10/567,532

Office Action Summary	Application No. 10/567,532	Applicant(s) GRIESBECK, KARL	
	Examiner JASON K. NIESZ	Art Unit 3751

DETAILED ACTION

Figure 1 is Figure 1 from Dunn with labels added by the examiner.

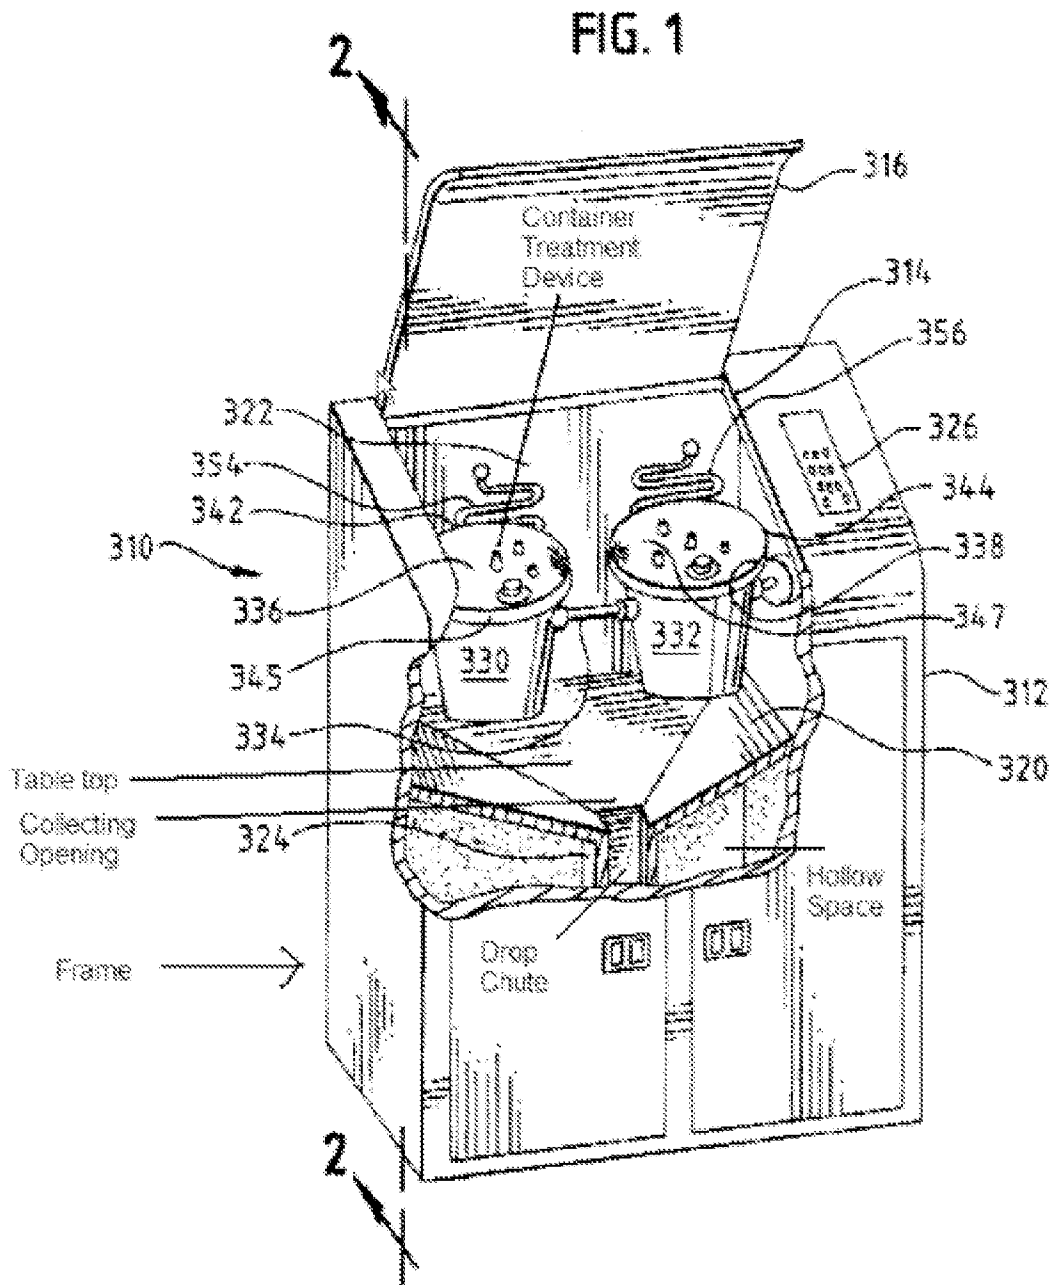
In Re claim 1 with reference to Figure 1 above Dunn discloses a container treatment machine comprising: a frame, a table top and a collecting opening wherein

the areas of said table top connected to the opening are inclined with falling slop to the collecting opening.

Dunn doesn't disclose an inspection device or a linear conveyor.

In Re claim 2 with reference to Figure 1 above Dunn discloses a drop chute connected to the collecting opening.

In Re claim 3 above with reference to Figure 1 above Dunn discloses a collecting opening having a rectangular shape and being centrally located in a rectangular table top.

In Re claims 4 and 5 with reference to Figure 1 above Dunn discloses a ring shaped hollow space between the drop chute and the outside walls of the frame. Statements of intended use have been considered and determined not to limit the structure of the invention beyond the scope of the prior art: the ring shaped space in the Dunn apparatus could be used to house control elements.
